**CERTIFICATE OF APPROPRIATENESS**

**Property:** 4 W 11th Place, Lot 2, Neighborhood Subdivision. The property includes a 2,651 square foot, two-story brick residence situated on a 10,000 square foot (80' x 125') interior lot.

**Significance:** Contributing American Colonial Style residence, and a landmark constructed circa 1920, located in the West 11th Place Historic District.

**Proposal:** Alteration –The applicant proposes the following:

**EAST ELEVATION – FRONT**

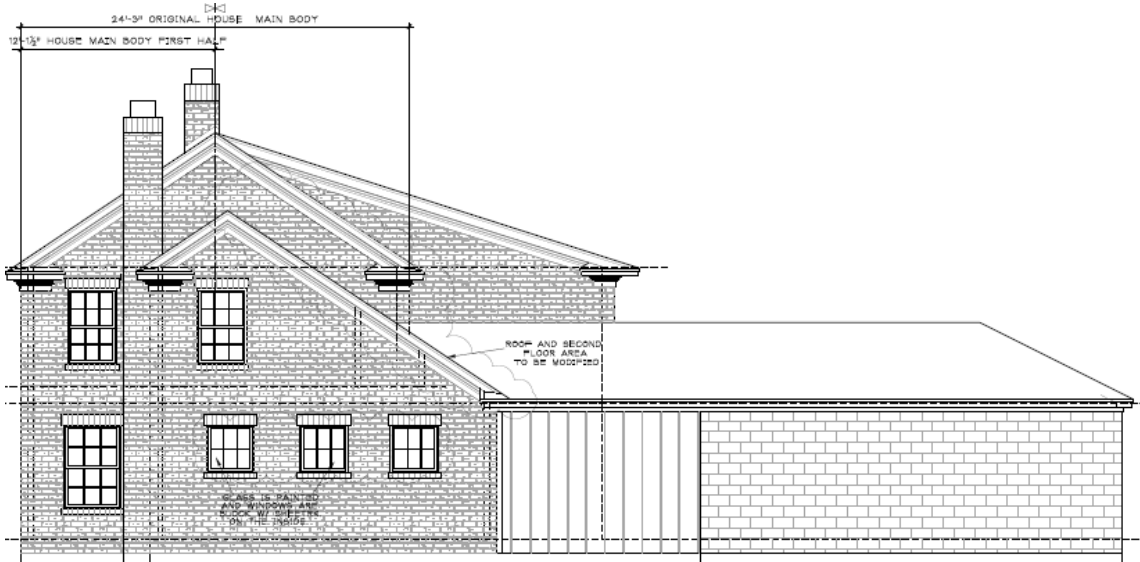
- **Replace** two existing arched, single-pane windows with two arched, wood, multi paned windows consistent with the aesthetic of other original 6/6 east (façade) elevation windows.

- **Addition** of a metal portico banister for safety. This COA was approved by the HAHC for previous owners on May 23, 2002. The existing original French doors above the portico are functional and open inward. The owners propose a simple 36" high iron railing that links with the aesthetic of the dormers and front door lunette windows. *Attached is a pdf with examples of other historical houses nearby with similar portico railings to what we are proposing in our drawings.*

**NORTH SIDE ELEVATION**

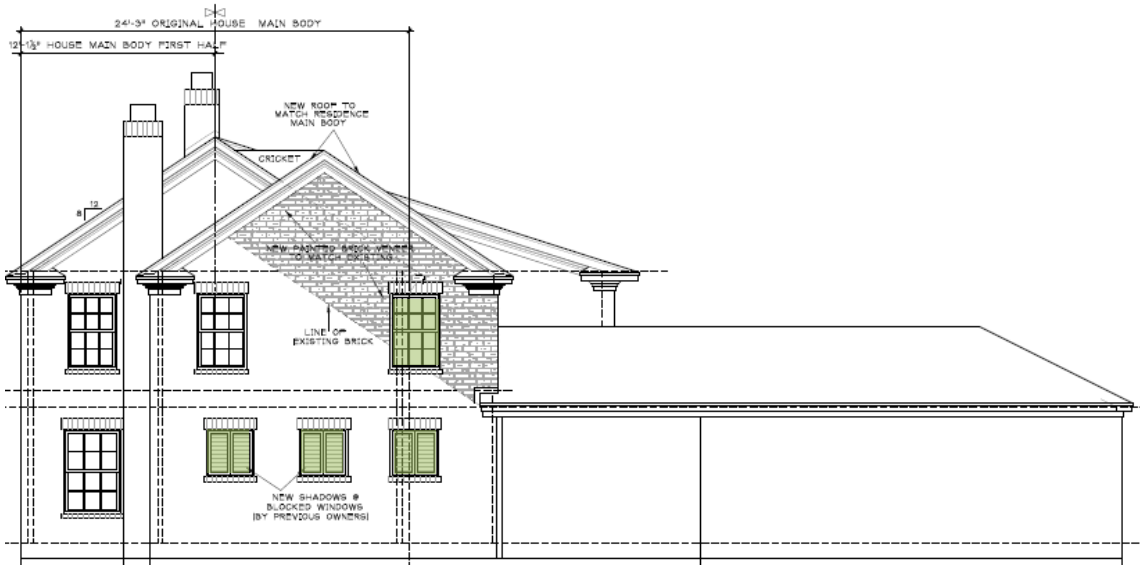
First floor:

- **Addition** of wood 'closed shutters' to existing painted (blocked off on interior) windows to improve aesthetic and keep protected.

- **Addition** of one 6/6 wood widow to match existing original windows on second level.

**SOUTH SIDE ELEVATION**

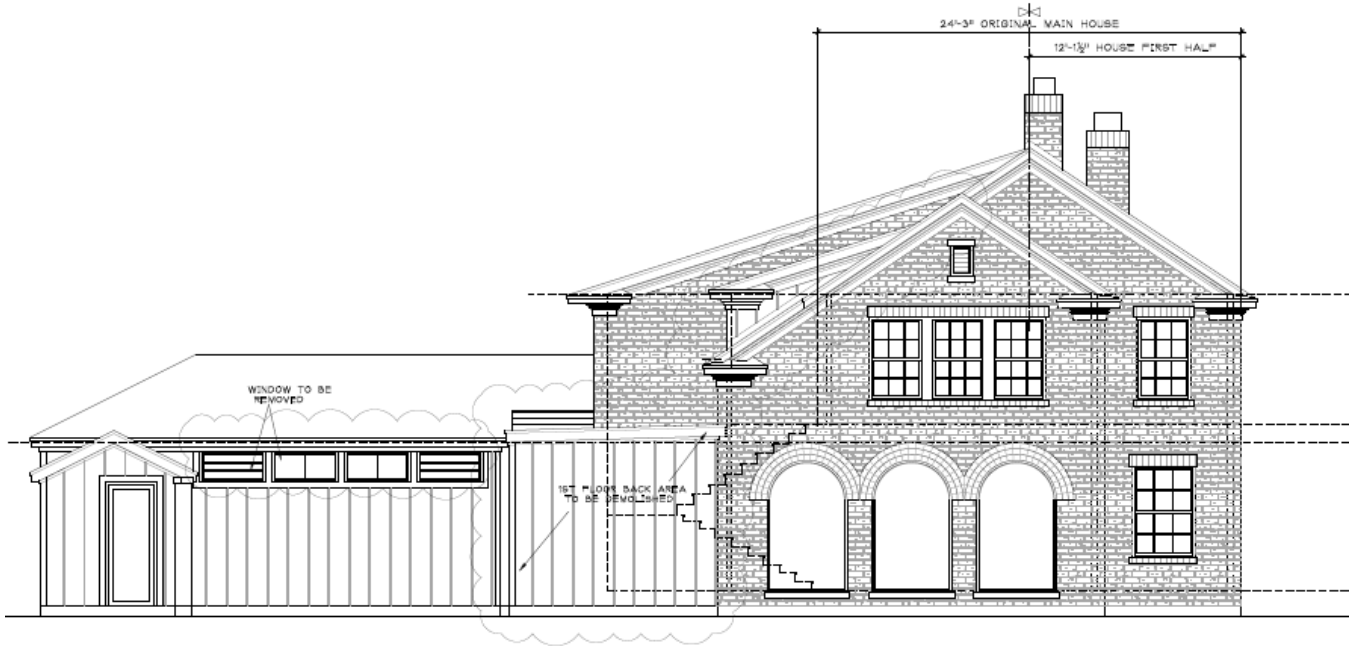
- **Replace** three existing arched, single-pane windows with three arched, wood, multi-pane windows consistent with the other original 6/6 East (façade) elevation windows.
- **Addition** of one 4/4 wood window proposed on south side of mudroom connecting garage to house

- **Addition** of three 6/6 wood window proposed to match existing three.

### WEST (REAR) ELEVATION

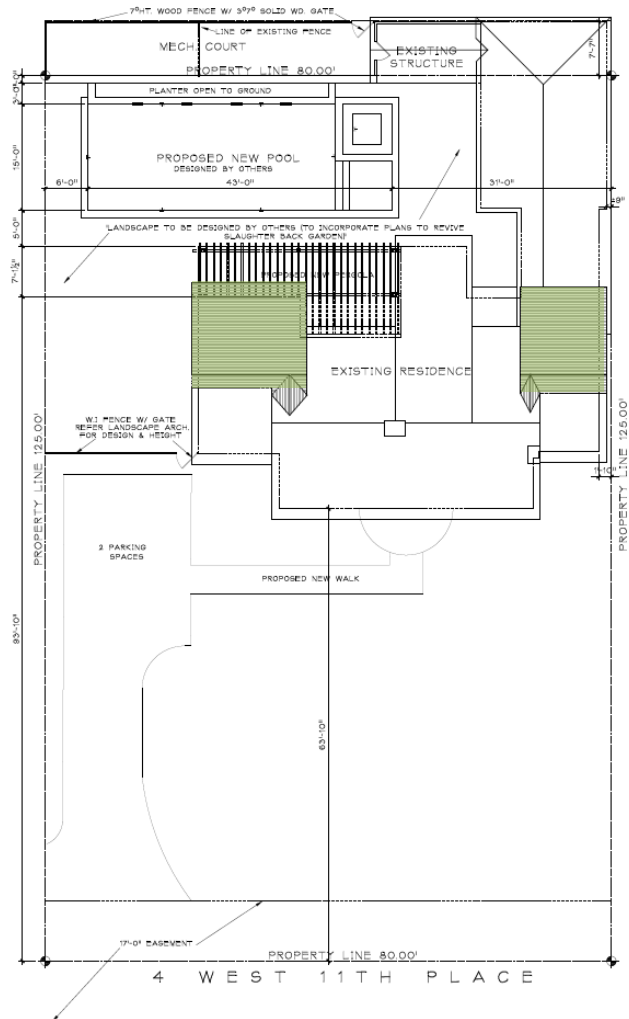
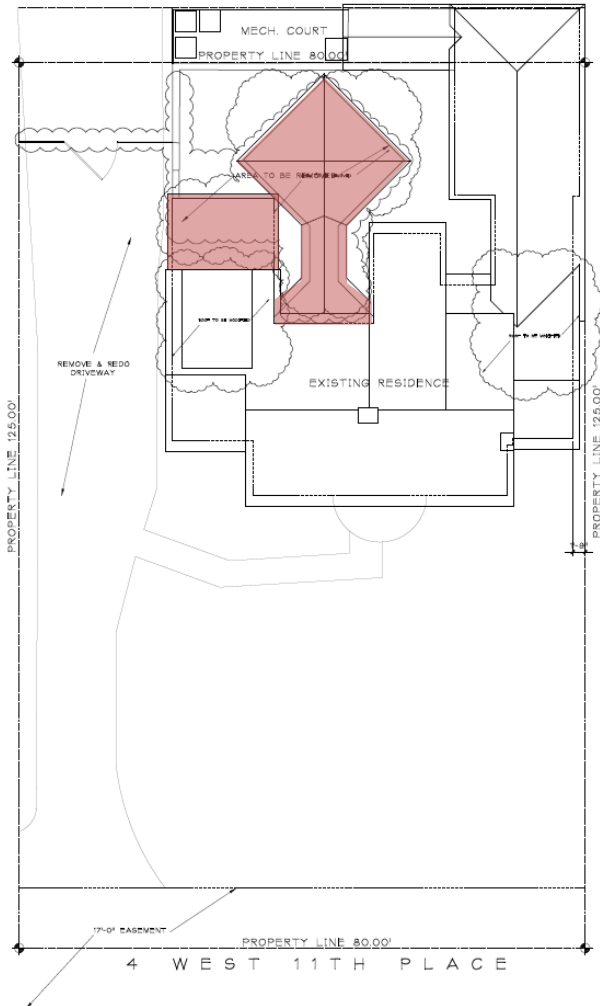
- **Addition** of two arched, wood, multi-pane French doors consistent with the other original 6/6 east (façade) elevation windows are proposed on first floor where office addition is being removed.
- **Replace** two French doors consistent with the existing to reflect removal of rear glass addition and need for better weather insulation.

- **Addition** of two 6/6 wood windows proposed to match the existing original east (façade) elevation and south (side) elevation existing windows.
- **Replace (due to repair)** existing 48 fix wood Palladian window with a smaller 27 fix Palladian window to accommodate changes to interior staircase and landing to bring stair height to code.
